Item 4.**Development Application: 15-17 William Street, Alexandria - D/2020/1059****File No.:** D/2020/1059**Summary**

Date of Submission:	The application was lodged on 19 October 2020.
Applicant:	David Findlay
Architect:	Derek Raithby Architecture
Owner:	Balglen Pty Ltd.
Planning Consultant:	ABC Planning
DAPRS:	2 February 2021
Cost of Works:	\$8,814,325
Zoning:	The proposed multi-dwelling houses are permissible with consent within the B4 Mixed Use Zone.
Proposal Summary:	<p>The proposal involves the demolition of an existing warehouse. It is intended to excavate and remediate the site and to construct 14 x terrace style, 3-4 storey multi dwelling houses. Torrens Title (stratum) subdivision of the site is proposed.</p> <p>The applicant has made a public benefit offer in order to provide community infrastructure contribution as required under Clause 6.14 of the Sydney Local Environmental Plan 2012 (SLEP2012). Consequently, the application is required to be determined by the Local Planning Panel. This is in accordance with the Local Planning Panels Direction - Development Applications, dated 30 June 2020.</p> <p>The applicant has made a public benefit offer to provide a monetary con

Figure 13: East elevation (William Street)

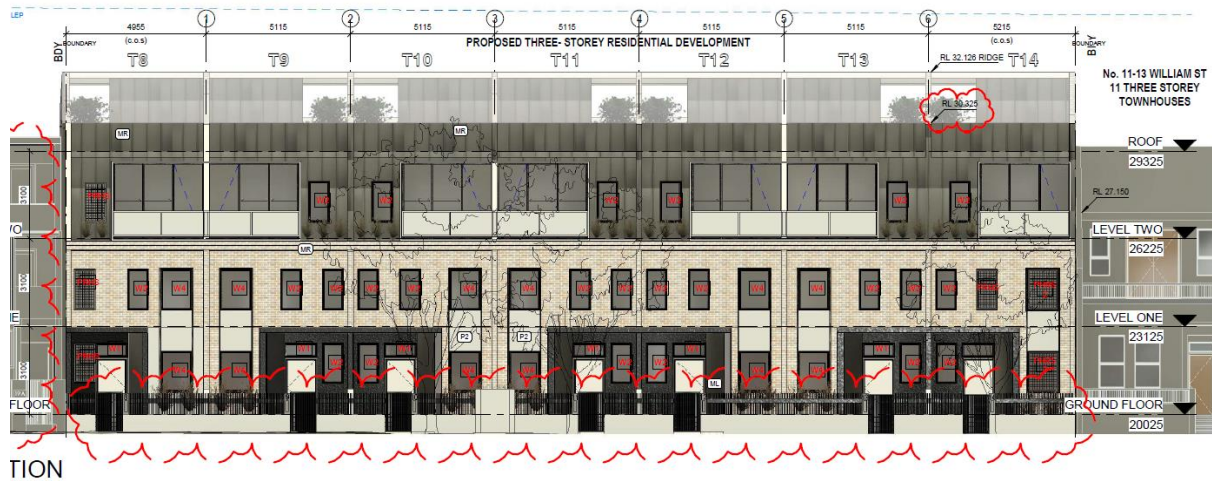
80. The building proposes facade treatments that are unclear in that the Schedule of Finishes refers to building materials 'or similar'. Front second level balconies use painted wall finishes that are incongruous to face brick lower sections and vertical wall cladding reads as a continuous vertical plane that adds to the excessive bulk of the upper level of the building.

Figure 17: Section Plan showing partial basement under dwellings T8-T14 (William Street) and above ground parking areas under dwellings T1-T7 (William Lane)

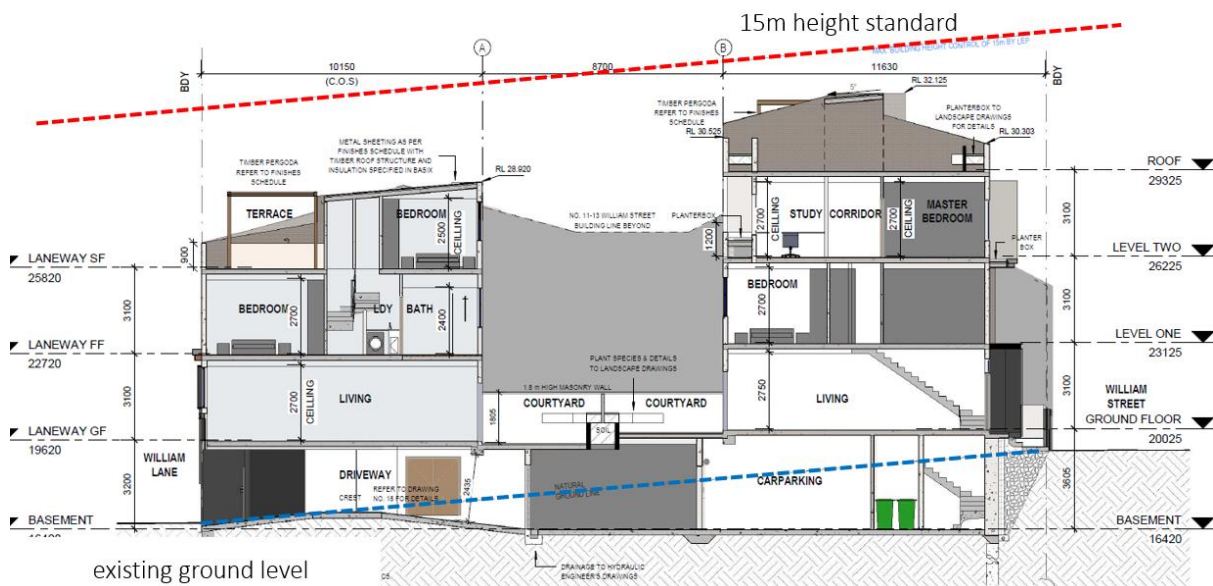
Provision	Compliance	Comment
4.1.1 Building height	No	SDCP2012 recommends a maximum building height of 3 storeys. The proposal has a height of 4 storeys at the western edge of the development. See further details in the 'Discussion' section below.

Figure 19: ground level parking area facing William Lane (shaded yellow) does not satisfy the SLEP2012 definition of a 'basement'

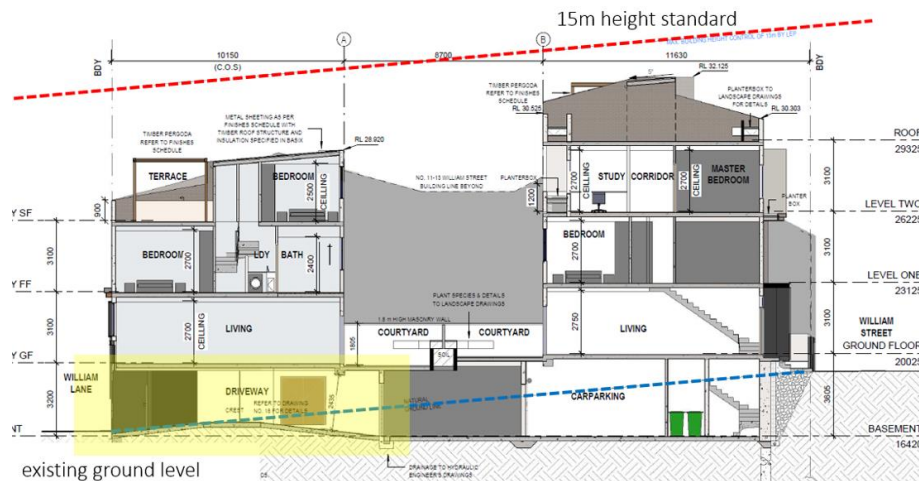
44. The areas excluded by the applicant include approximately 73sqm of GFA that when included, result in a GFA of 1,710sqm and a FSR of 1.55:1. The proposal exceeds the permissible standard by 50.5sqm or three per cent.

45. These areas include a communal waste bin storage room (20sqm), bin storage areas, a second car parking space beneath dwelling T2 that exceeds the maximum car parking provision at Clause 7.5 of SLEP; and motorcycle parking spaces beneath each dwelling that are not required by SDCP2012 controls.

51. The applicant has provided GFA diagrams with the amended proposal that show FSR: 1.48:1 (GFA: 1,629sqm). However, the GFA diagrams do not include approximately 72.6sqm of GFA located within the ground level of the site at William Lane (beneath dwellings T1-T7), including a communal garbage room and areas of GFA located within the garages of dwellings T1-T7.

Figure 21: 8.7m building separation and opposing windows

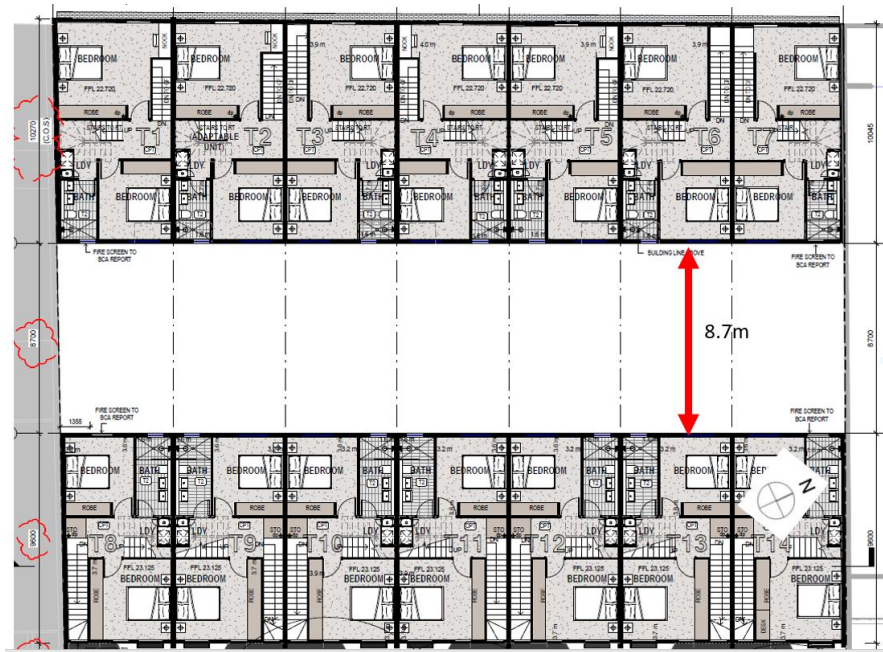
64. Amended drawings show a separation distance of 8.7m between the eastern and western rows of townhouses. The separation distance fails to provide adequate separation between habitable rooms that have opposing windows. Poor residential amenity results from compromised visual and acoustic privacy (Figure 21 below).

Figure 22: obscure-glazed windows and balconies at 29-41 William Street (source: applicant drawings)

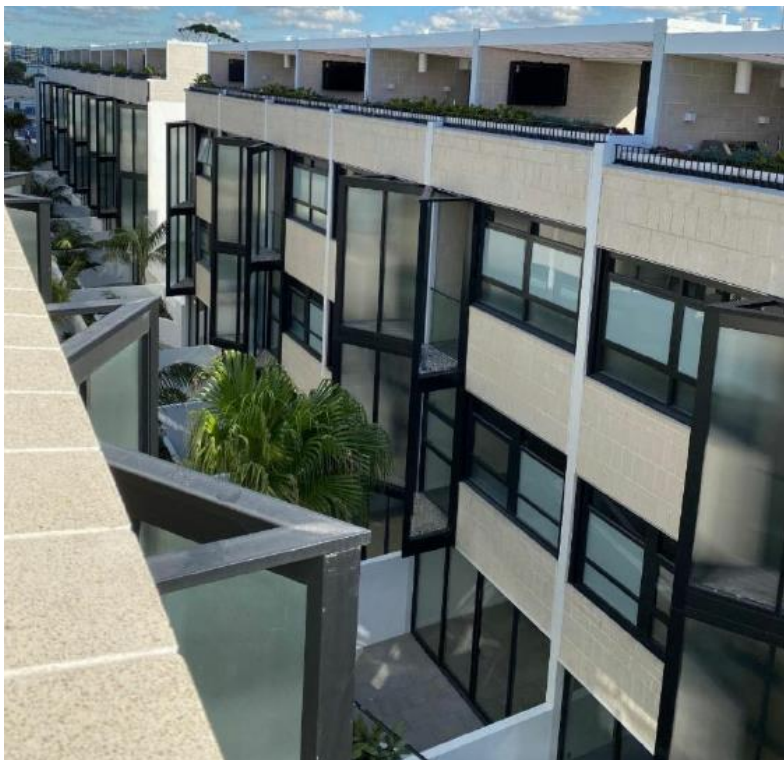
65. The applicant states that the minimal separation strategy follows the approach adopted within a development to the south of the site at 29-41 William Street. Opposing dwellings are separated by 7.7m. This development has used obscure-glazed windows and obscure-glazed, angled balconies that face the internal courtyards (Figure 22 below).

Figure 23: Proposed windows facing internal courtyards within the subject site, with fixed, obscure-glazed windows to 1.8m and operable windows above

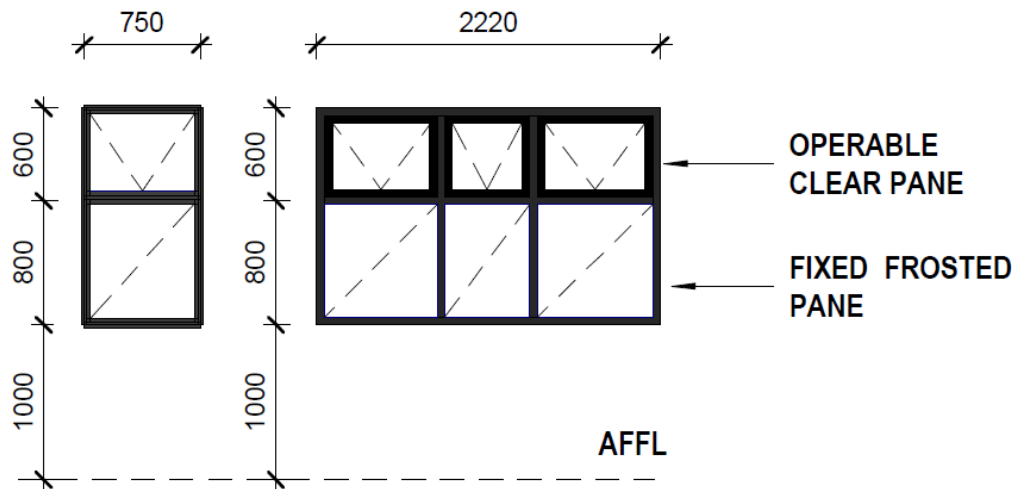
66. The subject proposal provides fixed and obscure glazed windows to a height of 1.8m with smaller operable windows above that height (Figure 23 below). The fixed and obscure glazed windows reduce natural cross ventilation to the dwellings and create a sense of enclosure within bedrooms.
